PLAN VIEW THOMAS JEFFERSON MEMORIAL NATIONAL MALL AND MEMORIAL PARKS

128232 SHEET 6 of 54

TITLE OF SHEET WEST TRANSITION **PLAN**

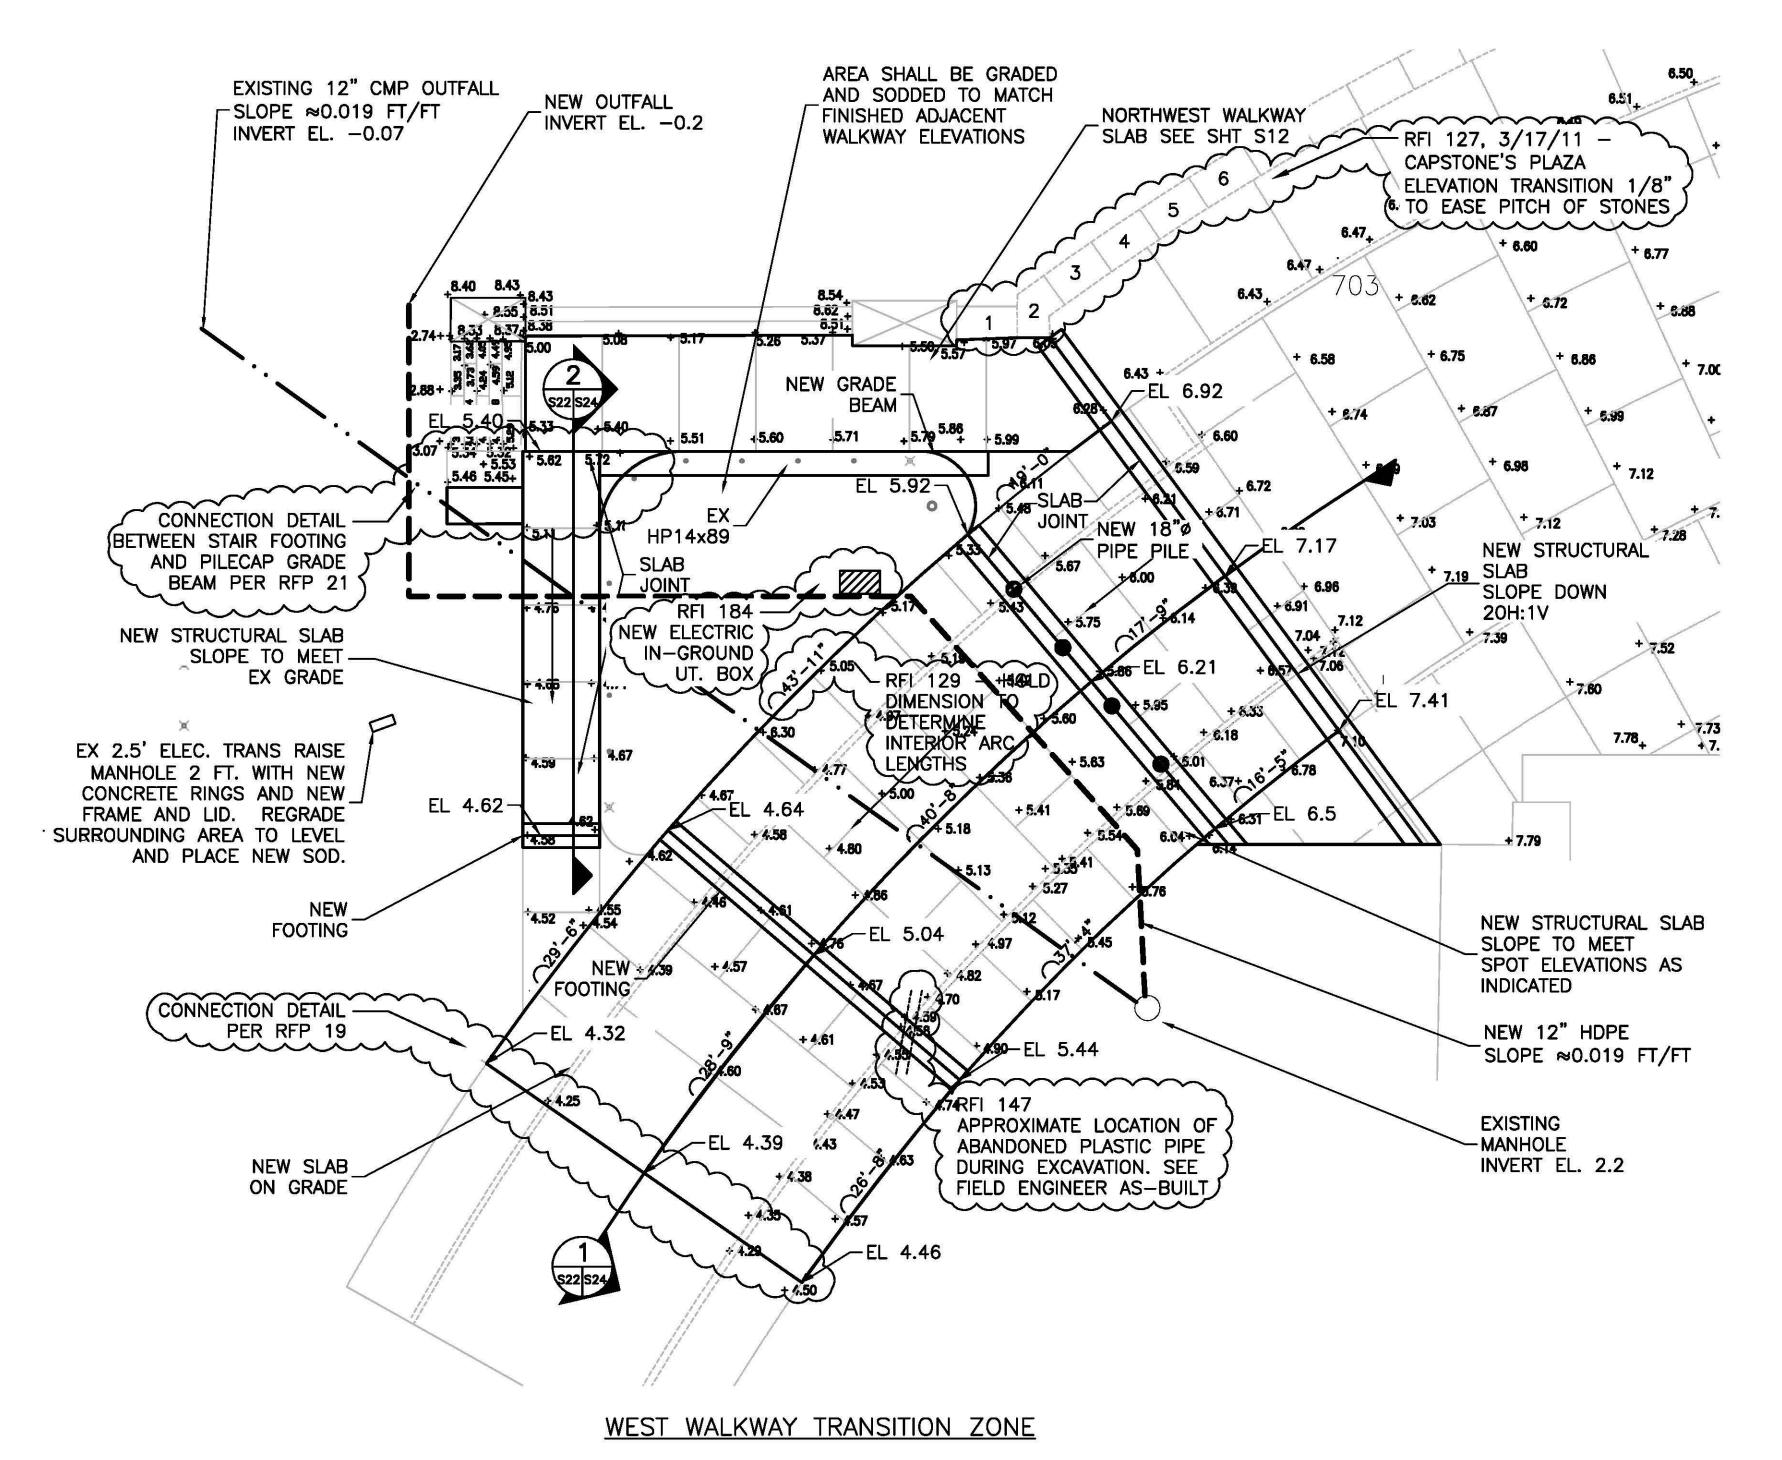
RFI 148, 5/18/11 GRATES SHALL NOT BE RE-INSTALLED; REPLACE WITH GRANITE CURB STONES; GRATES TO BE PROVIDED TO NAMA

RFP 22 "TREES" 2 WHITE PINE 1 HIMALAYAN PINE

↑ 01-03-11 REVISIONS TO TRANSITION ZONES

EAST TRANSITION
PLAN

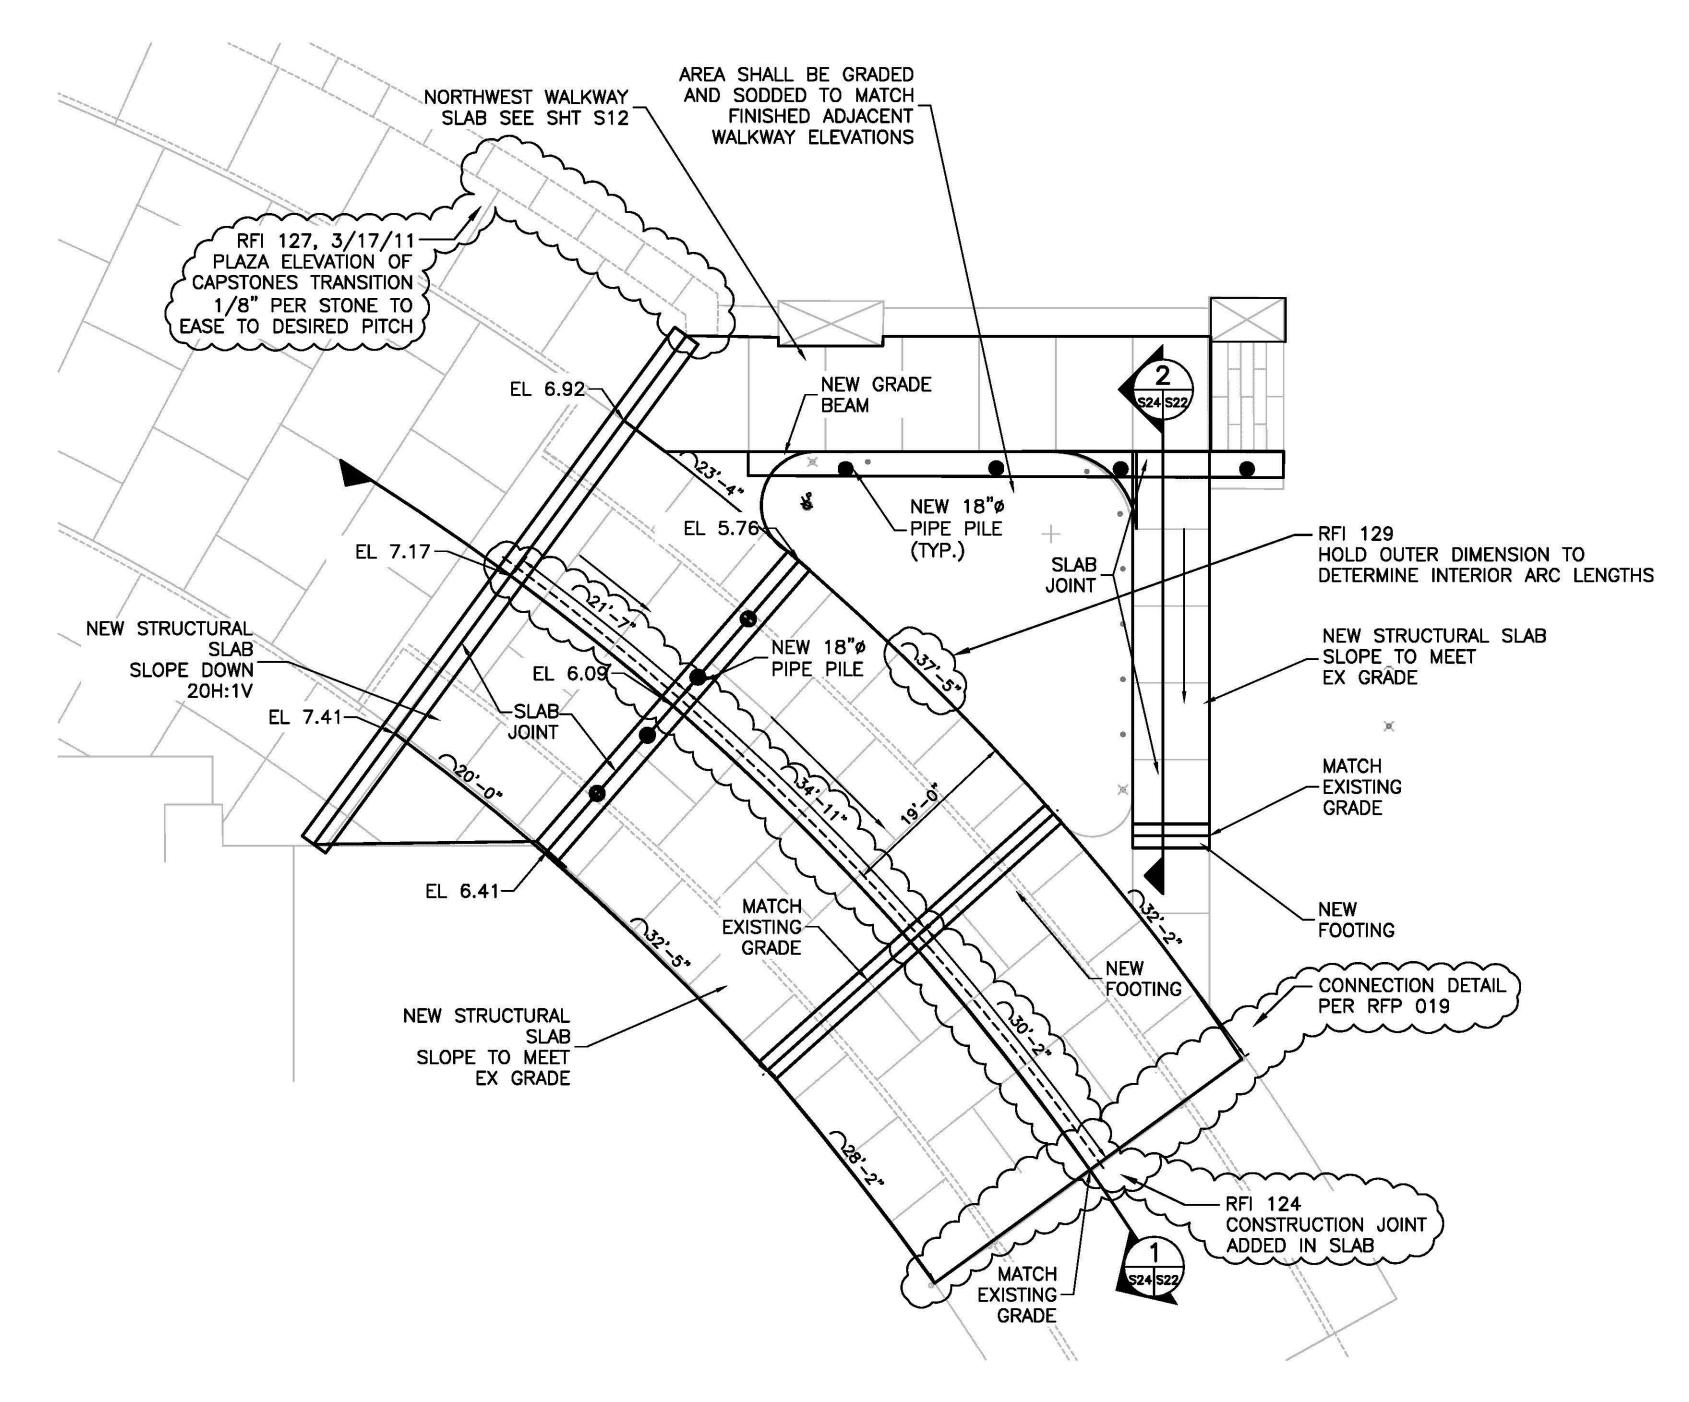
RFI 148, 5/18/11
GRATES SHALL NOT BE
RE-INSTALLED; REPLACE
WITH GRANITE CURB
STONES; GRATES TO BE
PROVIDED TO NAMA

RFP 22 "TREES"
2 WHITE PINE
1 HIMALAYAN PINE

RFI 188

BOND BREAKER TO BE PLACED ON

STRUCTURAL SLAB PRIOR TO EXPOSED

AGGREGATE TOPPING COURSE AT RING

ROAD (NOT SIDEWALKS)

SCALE OF FEET 1 01-03-11 REVISIONS TO TRANSITION ZONES
